# ADDENDUM NO. 1

**PROJECT NO:** STPSU-0220(256)  
**PROJECT DESCRIPTION:** INSTALLATION OF A ROUNDABOUT AT NORTH SECTION STREET/SCENIC 98 (VETERANS DR)/MAIN STREET  
**PROJECT OWNER:** CITY OF FAIRHOPE  
**OWNER REP / ENGINEER:** VOLKERT INC. / JORDAN STRINGFELLOW, P.E.  
**DATE OF ISSUE:** November 15, 2024  
**RECIPIENT:** Meeting Attendees and Plan Holders

STPSU PROJECT ROUNDABOUT INSTALLATION

**REVISED PLAN SHEETS**  
**NOVEMBER 15, 2024**

| STPSU-0220(256)      | 2024        | 2C       |

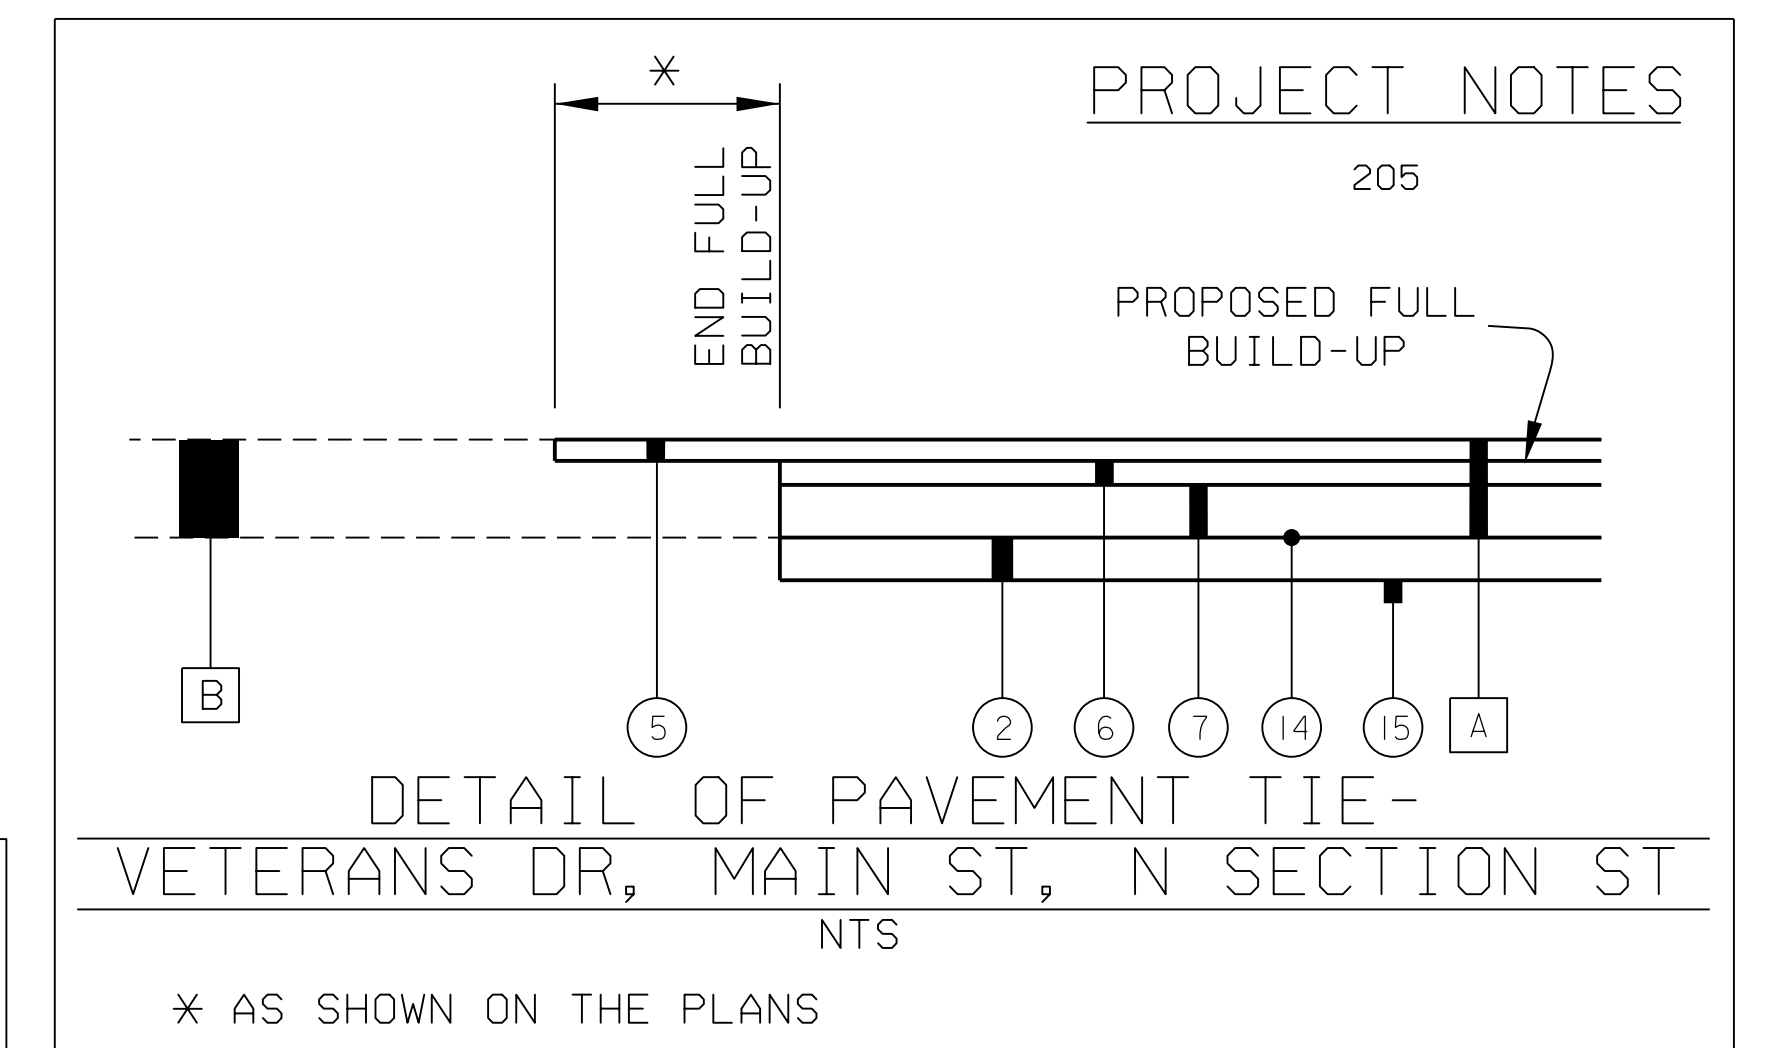
14. Where is the pay item 305A-037 Crushed Aggregate, Section 825 being used?

**ANSWER:** The pay item 305A-037 Crushed Aggregate, Section 825 is removed from the plan set and unit price bid schedule and replaced with pay item 305B-078 Crushed Aggregate, Section 825, Type B, For Miscellaneous Use. The location of use of this pay item shall be on driveways. See detail on sheet 2C and paving layouts on sheet 10.

REV 1:  
REVISED PAY ITEM  
FROM 305A-057 TO  
PAY ITEM 305B-078

| STPSU-0220(256)      | 2024        | 2        |

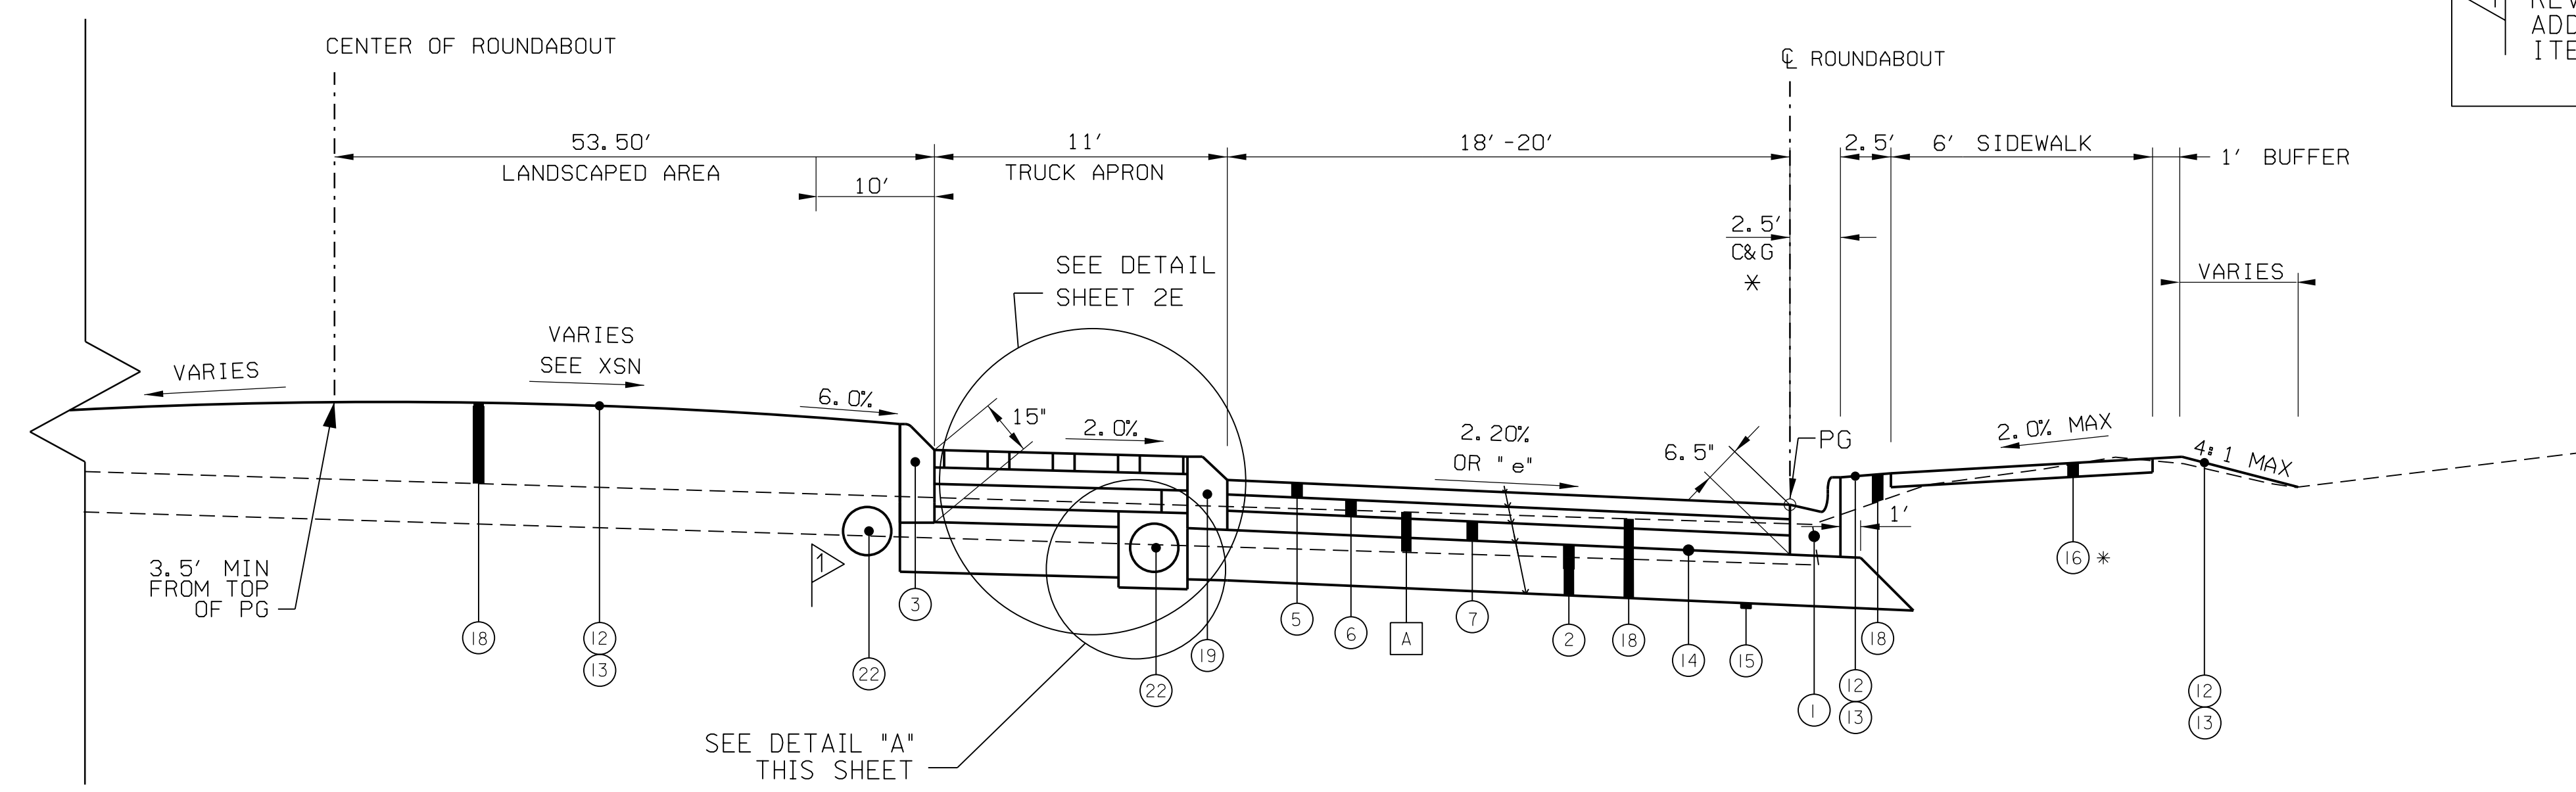
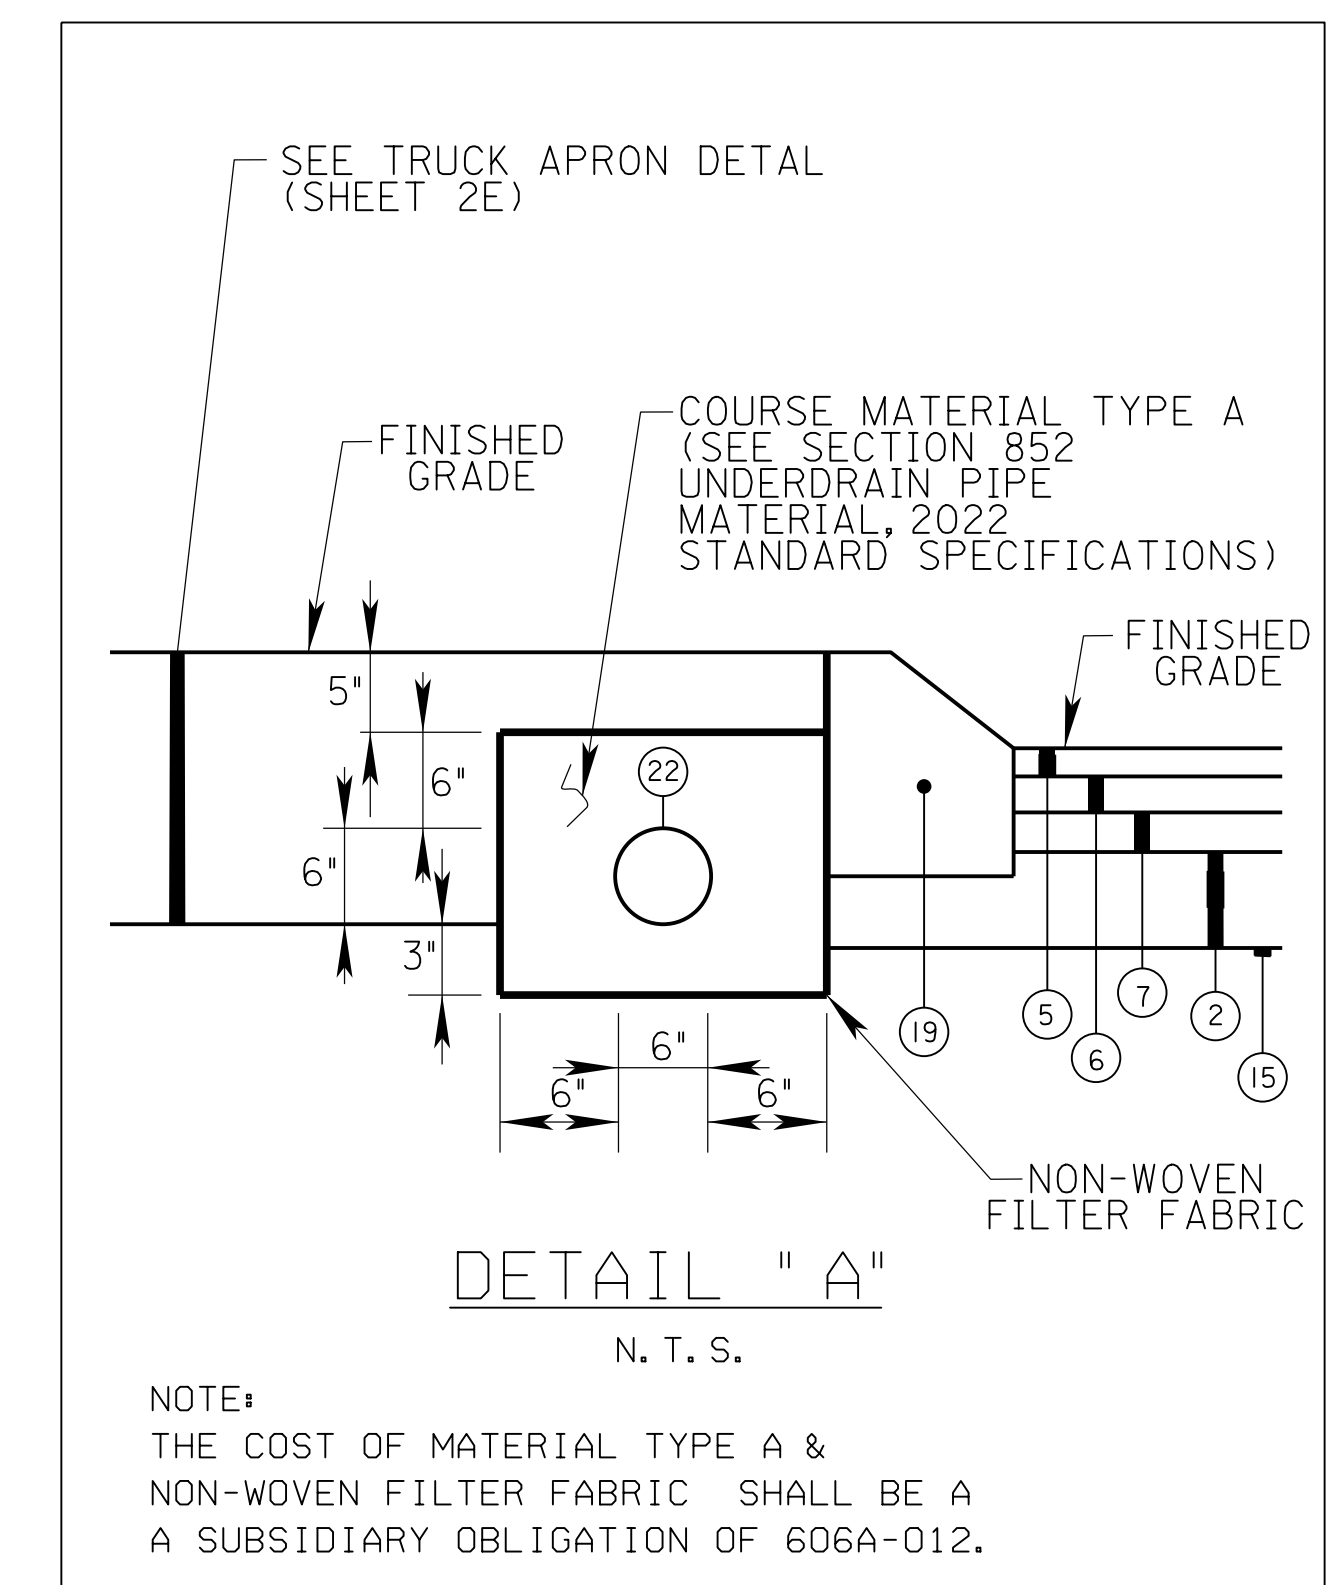
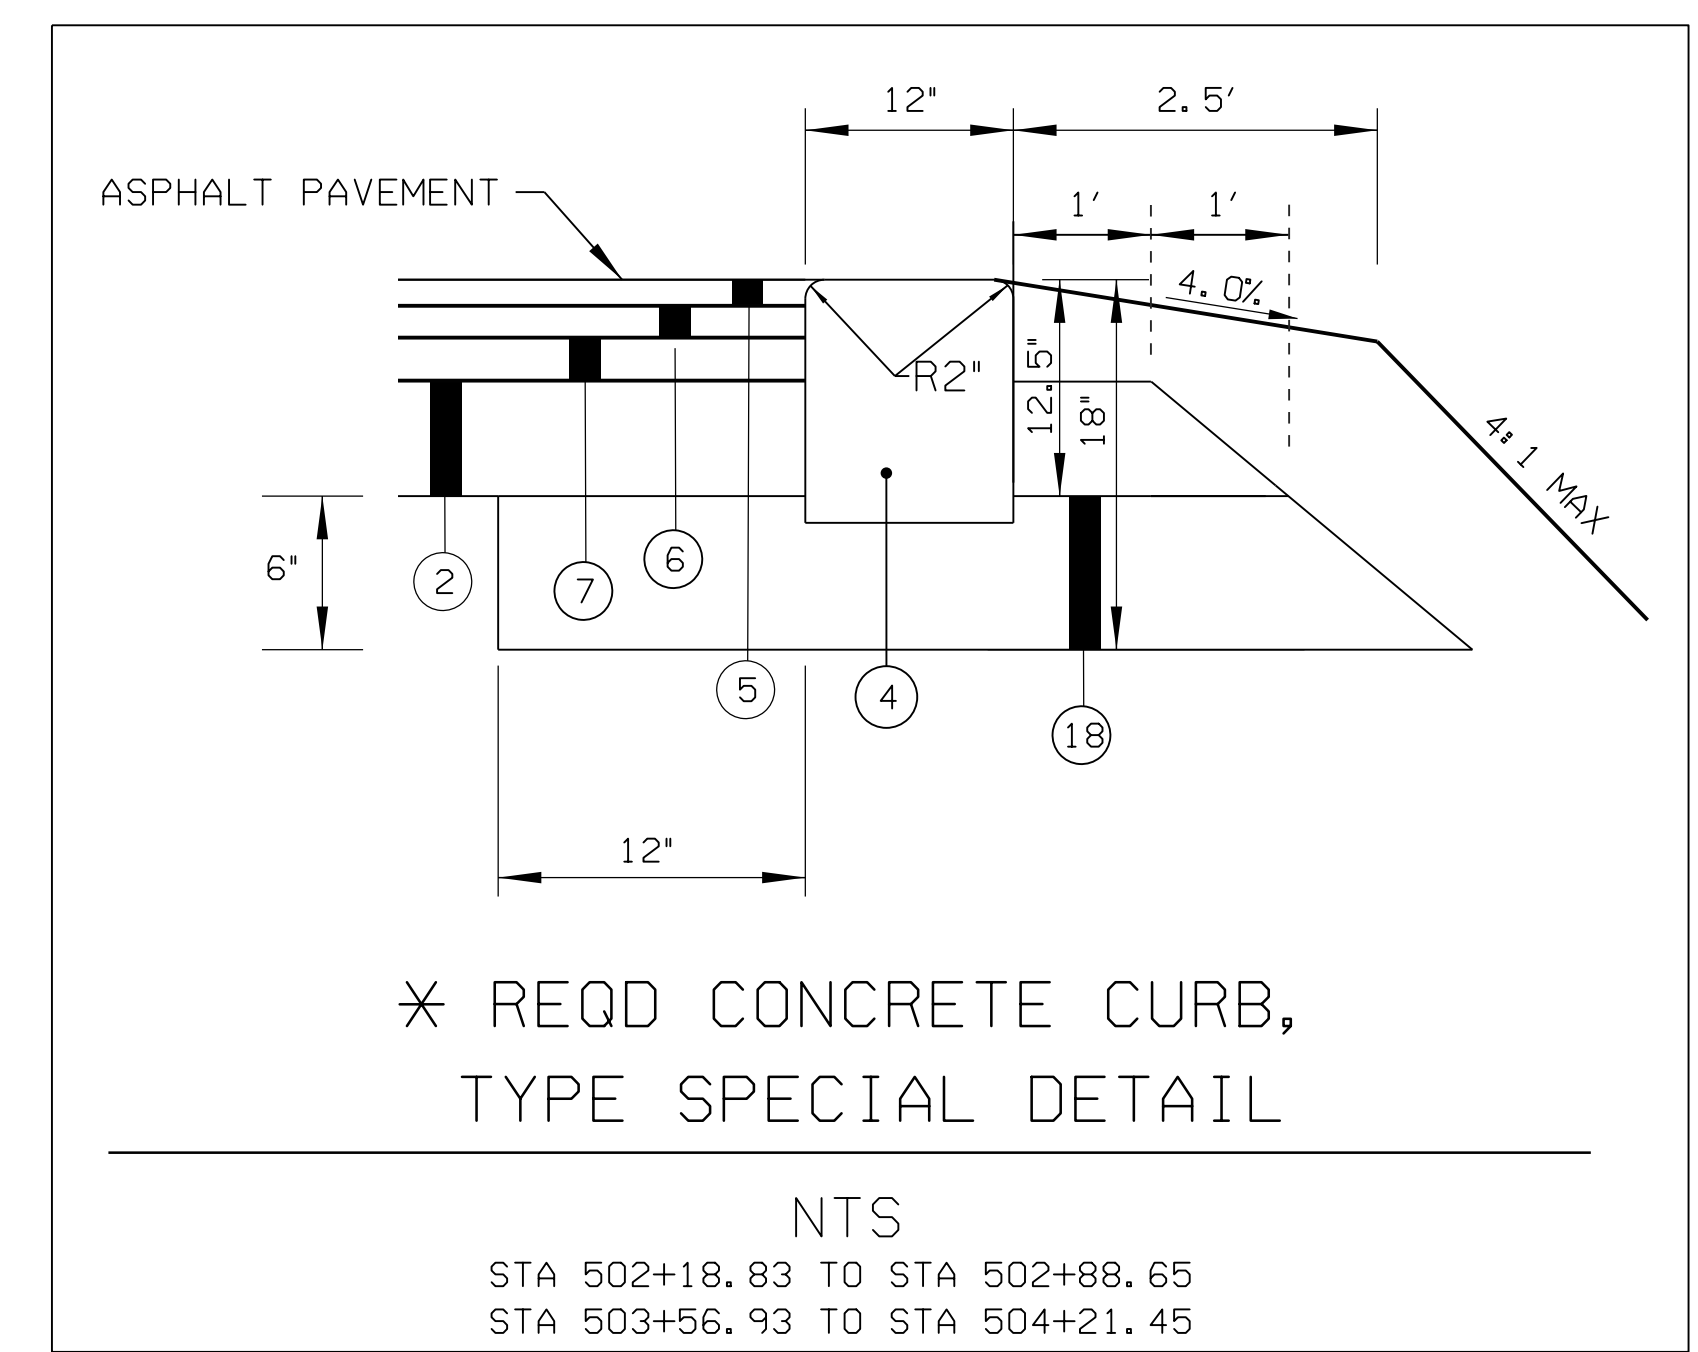
15. Should there be underdrain behind the interior curb of the inside of the roundabout?

**ANSWER:** Additional underdrain pay item 606A-009 was added to the contract. This is intended to be perforated polyethylene pipe. Ideally, this underdrain would tie in to drainage structure 13. If for some reason, the underdrain is routed below the travel lanes, the piece of pipe below the travel lane shall be solid pipe.

REV 1:  
ADDED UNDERDRAIN PAY  
ITEM 606A-009
